Road Safety Audit Stage 1/2

Proposed Highway Works

Reading International Business Park

Date: 25th May 2021

APPENDIX B

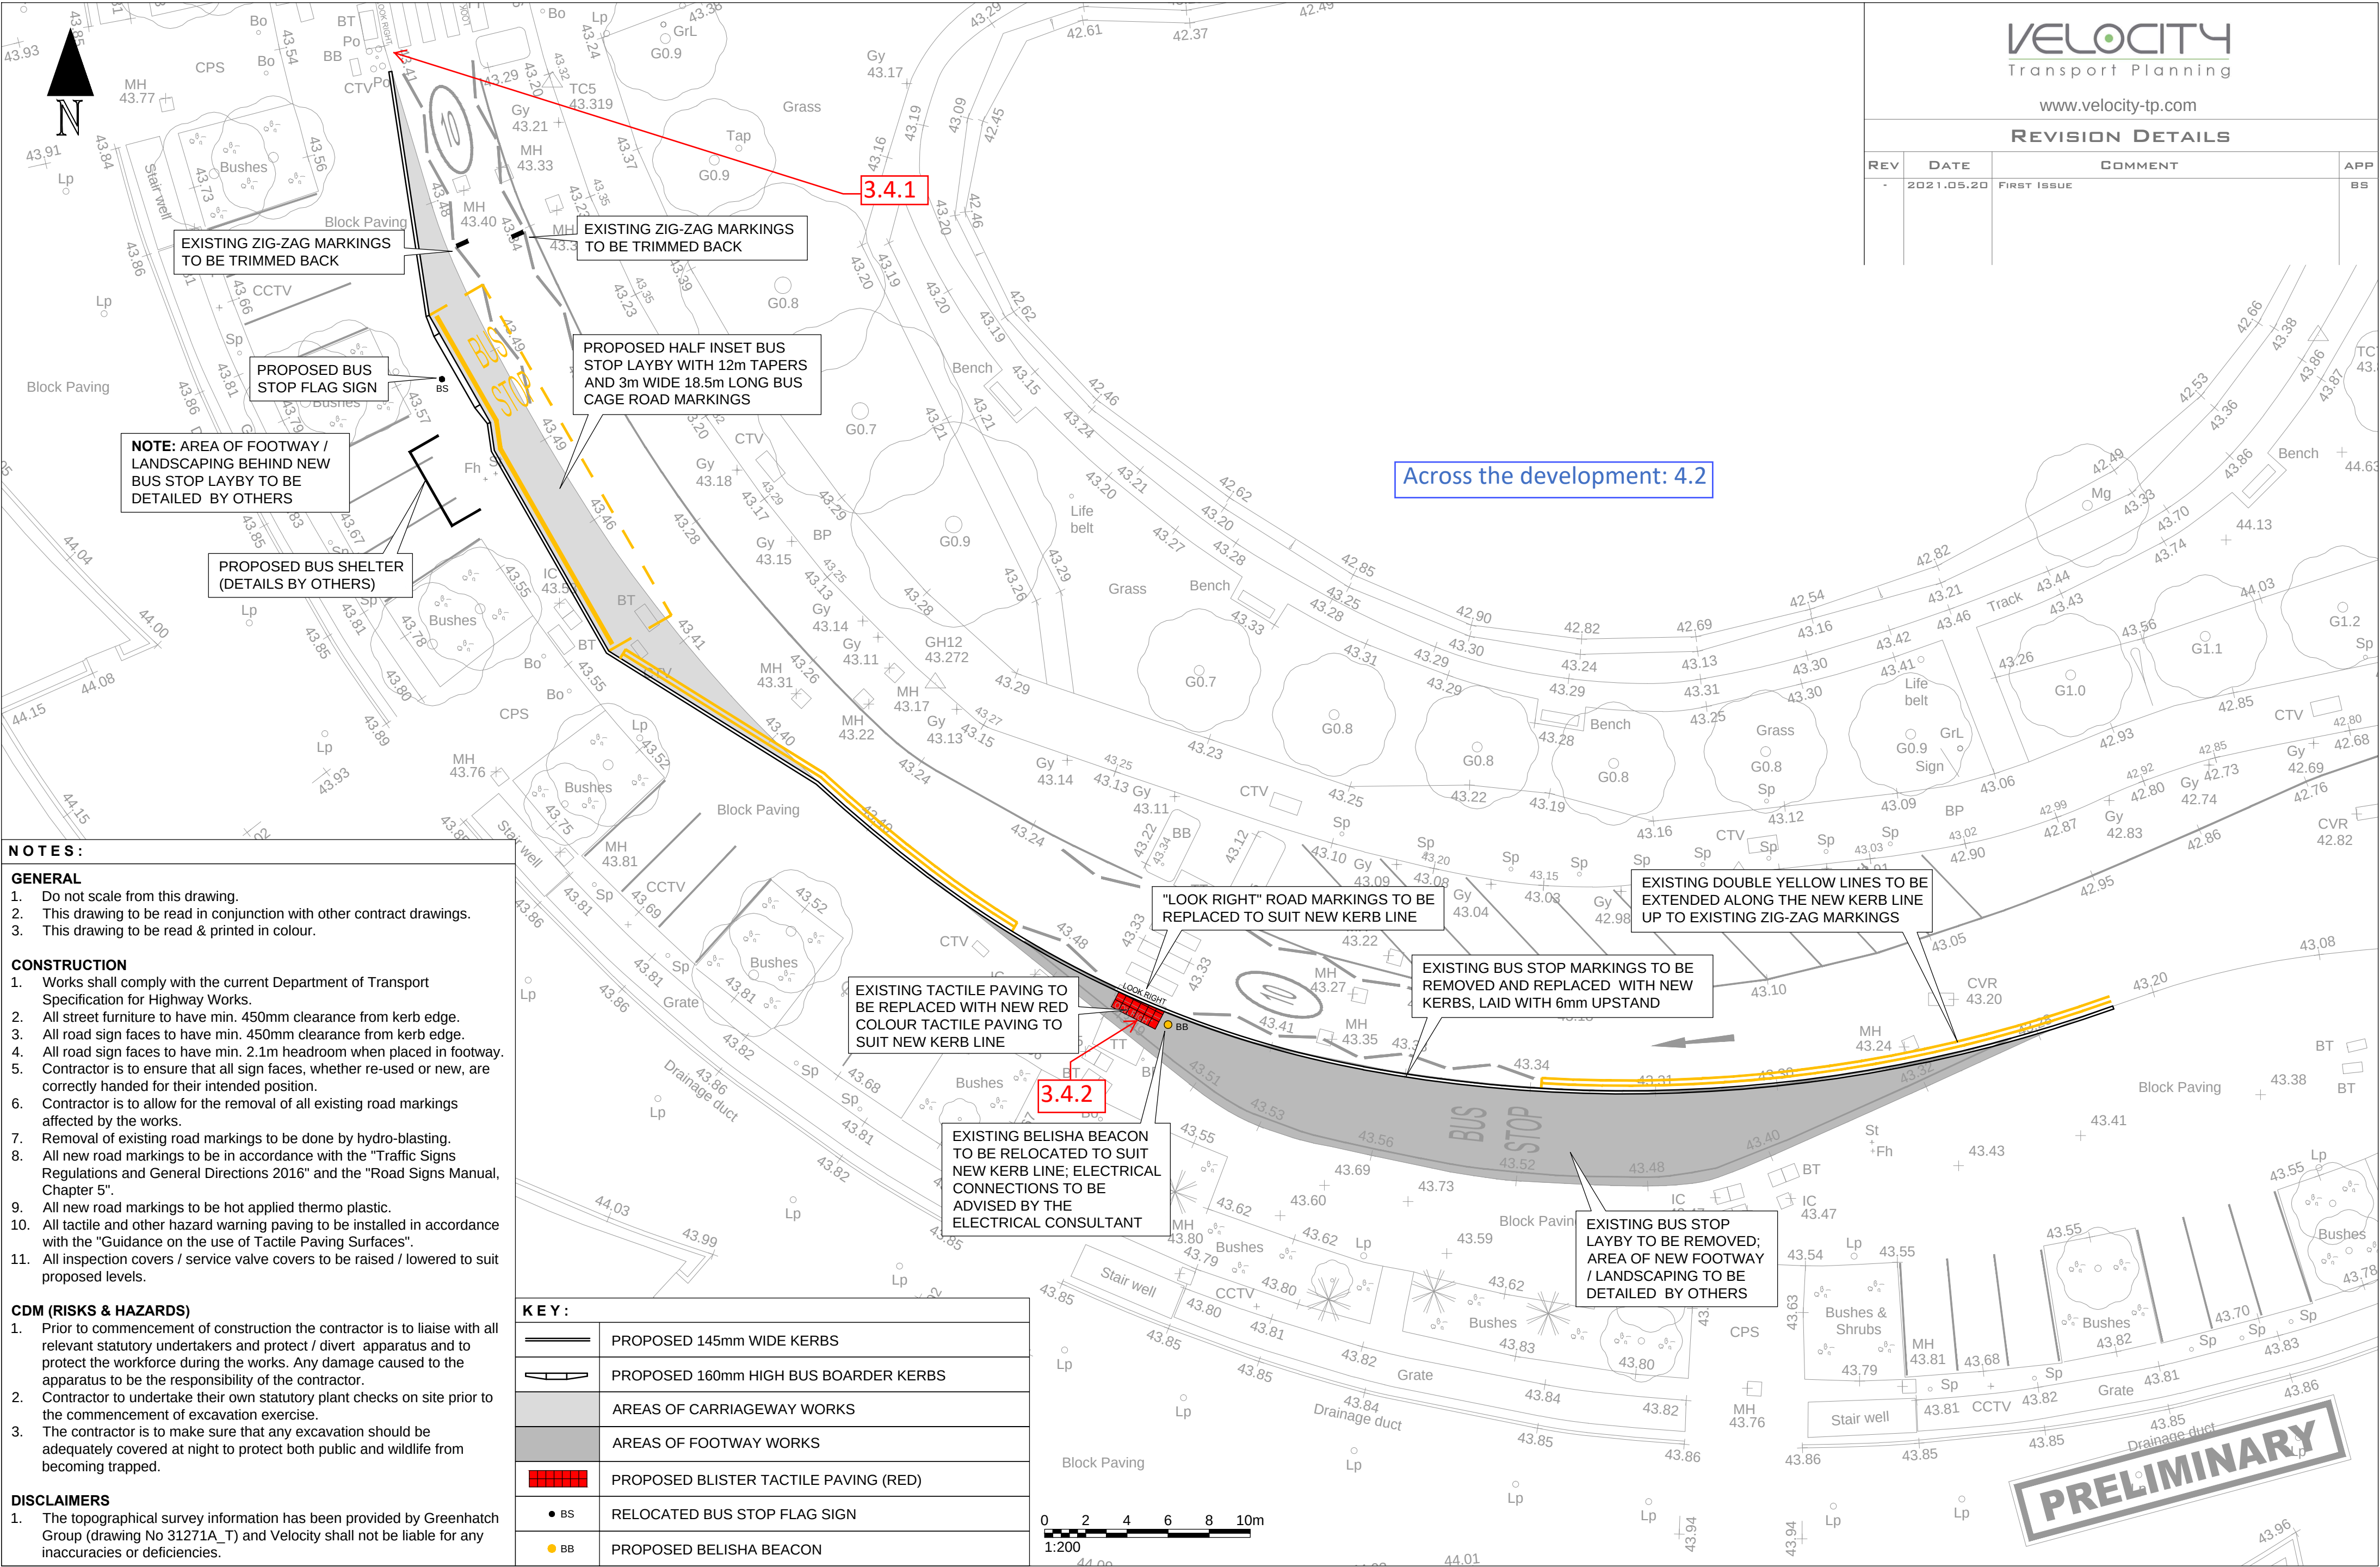
3.4.1 PROBLEM

Location: Zebra crossing, north of proposed bus stop.

Summary: Lack of intervisibility could lead to vehicle to pedestrian collisions.

The bus stop is proposed to be relocated to the immediate south of a zebra crossing, where no pedestrian / traffic intervisibility splays have been provided for assessment. A stationary bus at the bus stop could obscure a pedestrian leaving the footway on the western side of the carriageway to cross the road at the zebra crossing. This could lead to vehicle to pedestrian collisions though it is recognised that vehicle speeds are likely to be low.

It is recommended that the pedestrian / traffic intervisibility splays should be checked, where if insufficient the bus stops may need to be relocated or be fully inset.

3.4.2 **PROBLEM**

Location: Zebra crossing, southeast of proposed bus stop.

Summary: Inappropriate pedestrian facilities could lead to vehicle to pedestrian collisions.

There is no stem to the proposed tactile paving, where the presence of the crossing could be missed by blind or partially sighted pedestrians, though this is an existing situation. This could lead to the visually and mobility impaired pedestrians crossing at less safe locations and potential vehicle to pedestrian collisions.

It is recommended that the tactile paving should extend to the back of the footway in accordance with Department for Transport guidelines.

Intervisibility splays have been included in the updated drawings showing 11m visibility splays to the east of each crossing (given the road accommodates traffic in one direction).

The tactile paving has been shown without tails such that they are consistent with tactile paving the existing approved crossing points and to avoid confusion.
